Conversations from Canyon Mine 10/29/19 Inspection

Memorandum

Date: Type date here
To: Type recipient's name here
From: Type sender's name here
Subject: Canyon Mine Inspection on October 29, 2019

Comprehensive Request for Additional Information

Canyon Mine Conceptual Site Model

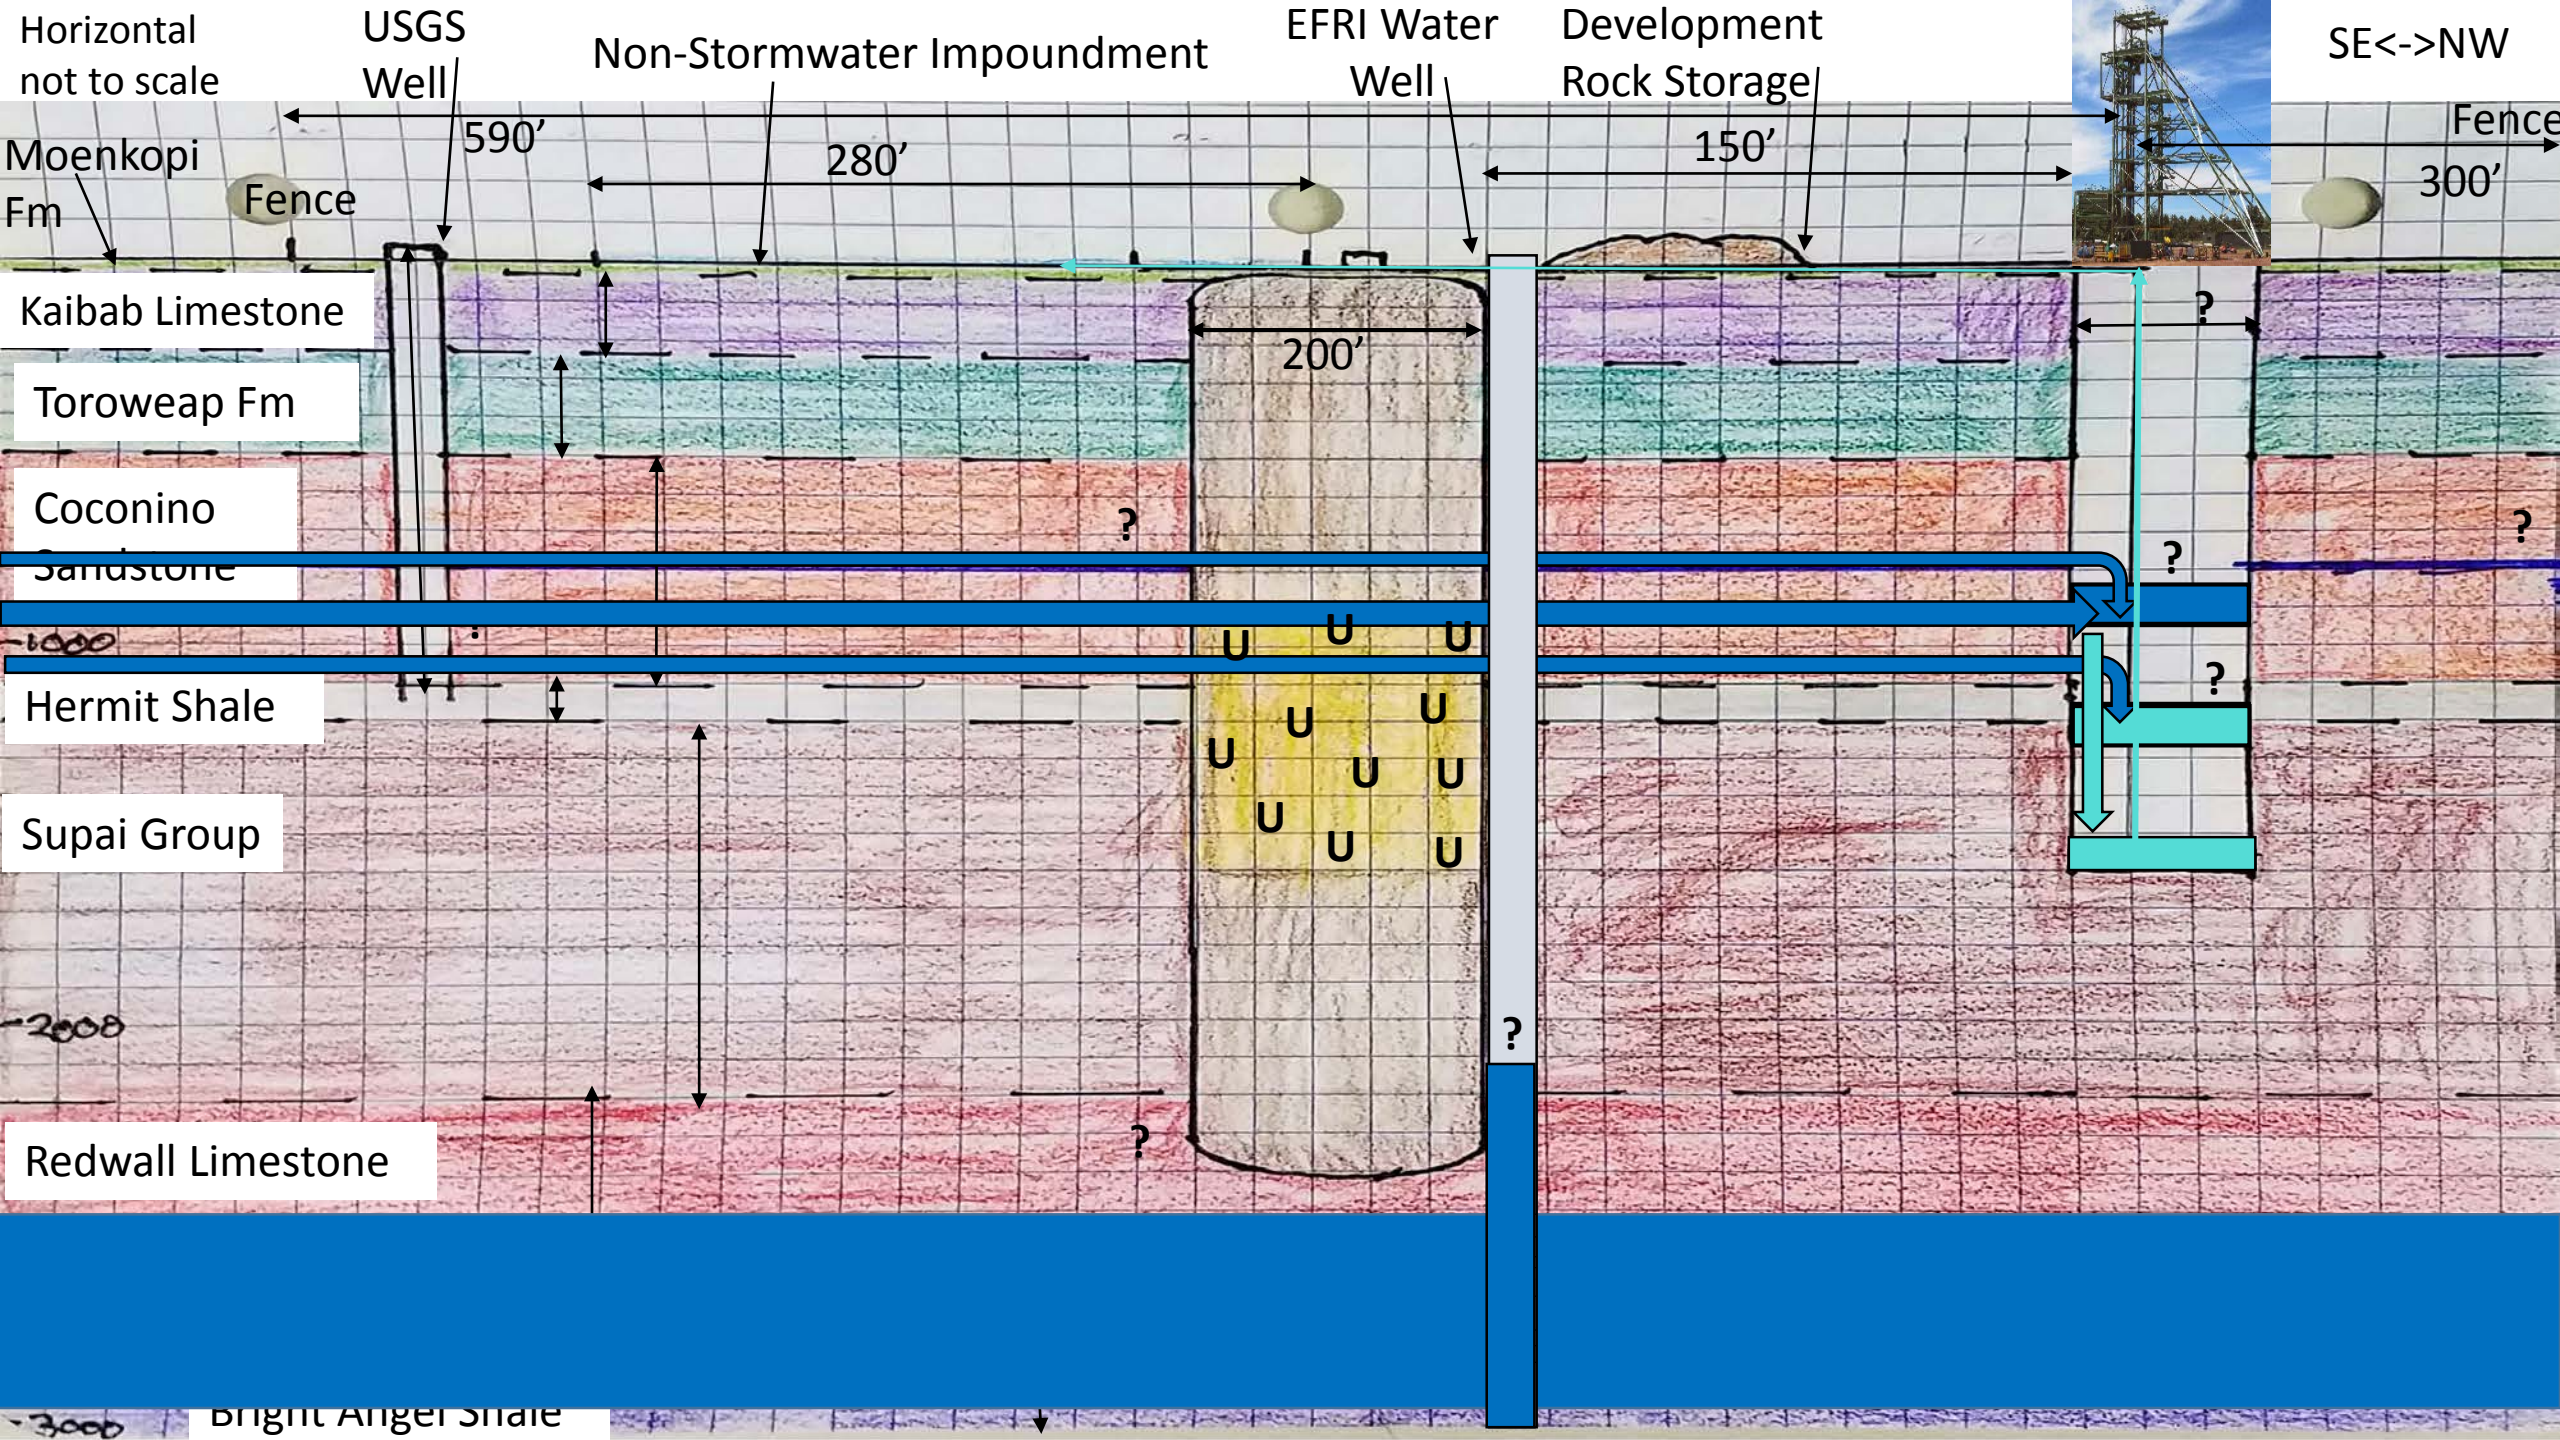
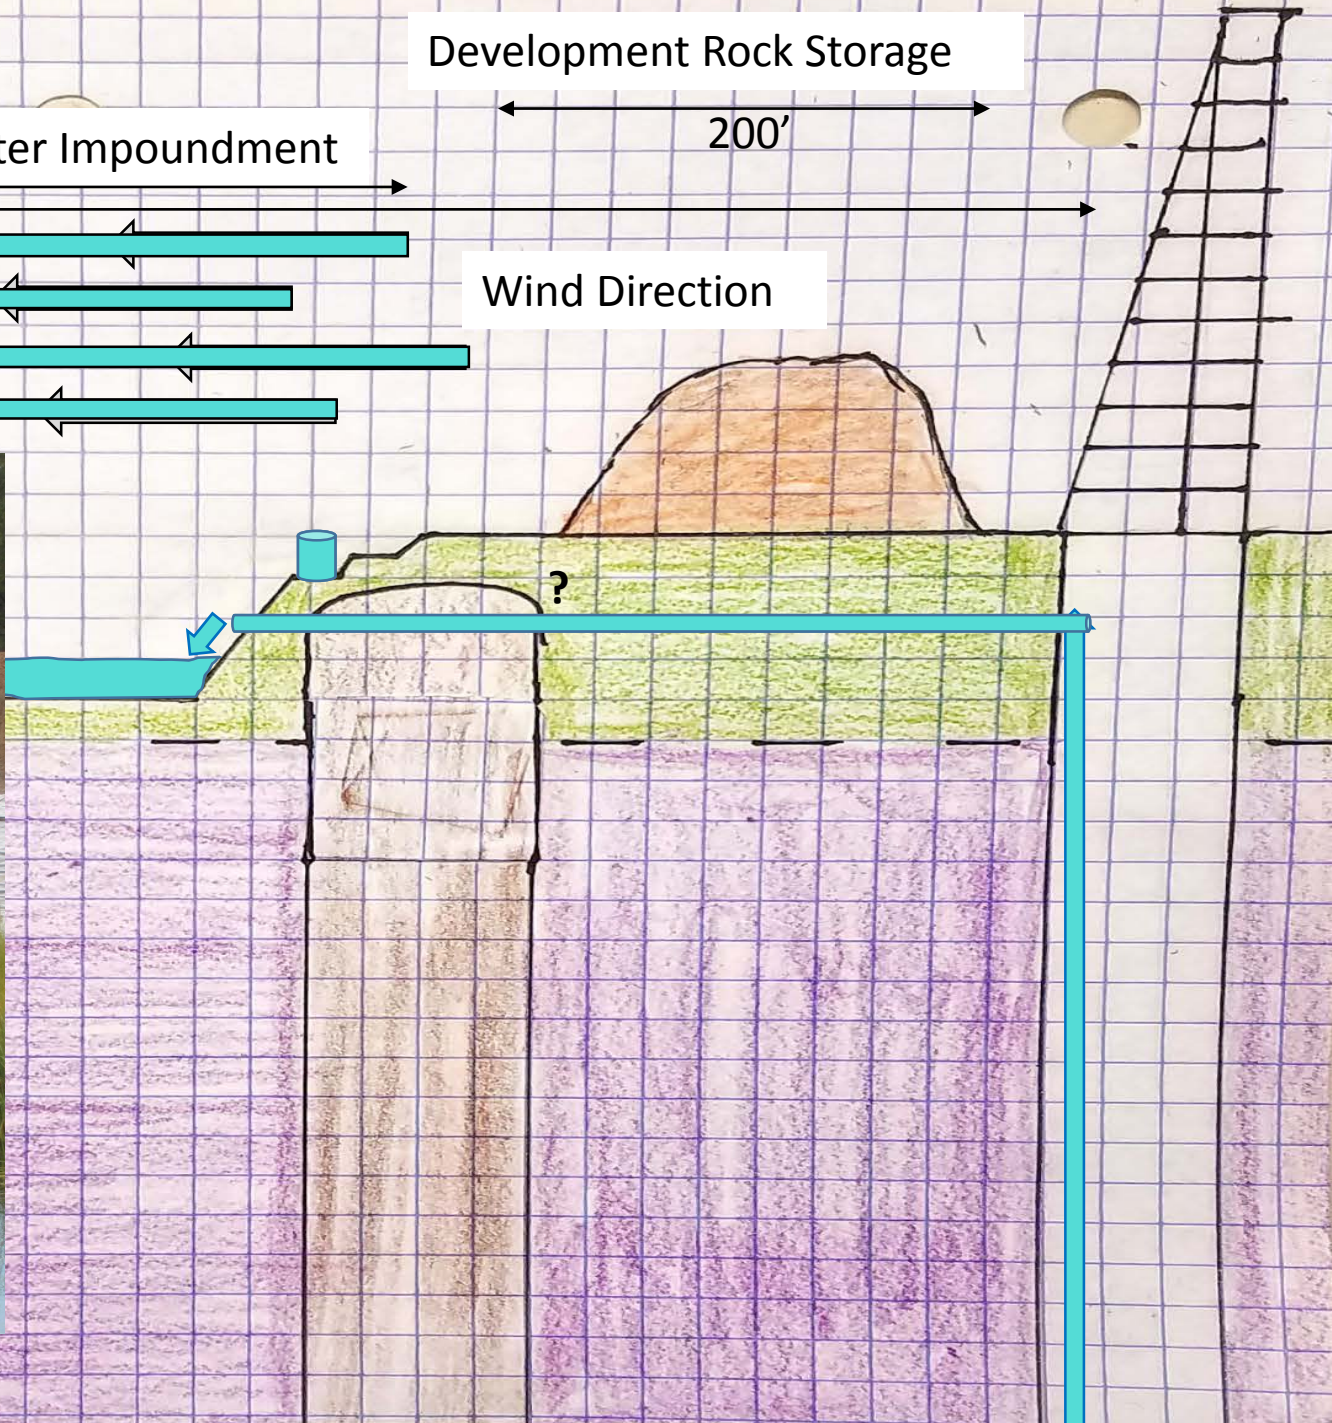
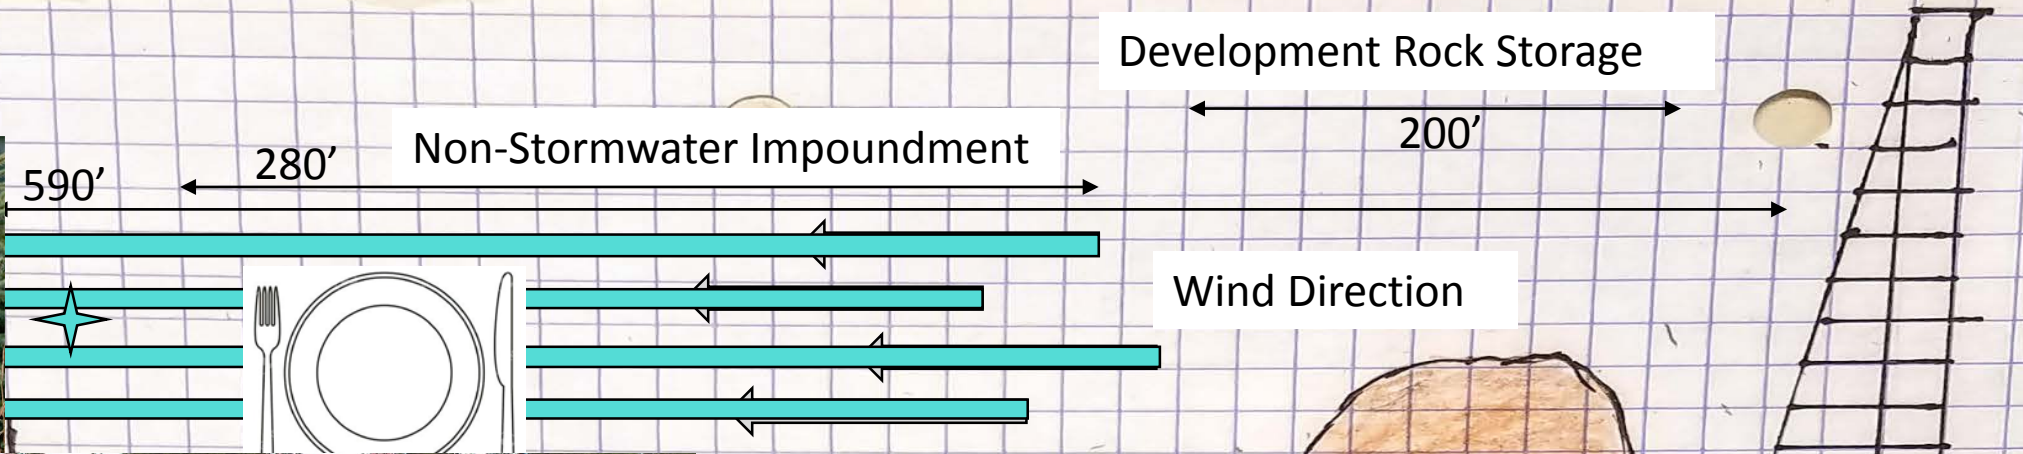
Original flow: 0.3 – 0.5 gallons per minute (gpm)(2009)
2018 flow: 18.4 gpm
2018 Data:
Antimony: 0.0068 – 0.0086 mg/l (AWQS: 0.006 mg/l)
Arsenic: 0.144 – 0.226 mg/l (AWQS: 0.05 mg/l)
Nickel: 0.227 – 0.284 mg/l (AWQS: 0.1 mg/l)
Uranium: 0.0915 – 0.128 mg/l (EPA MCL: 0.03 mg/l)
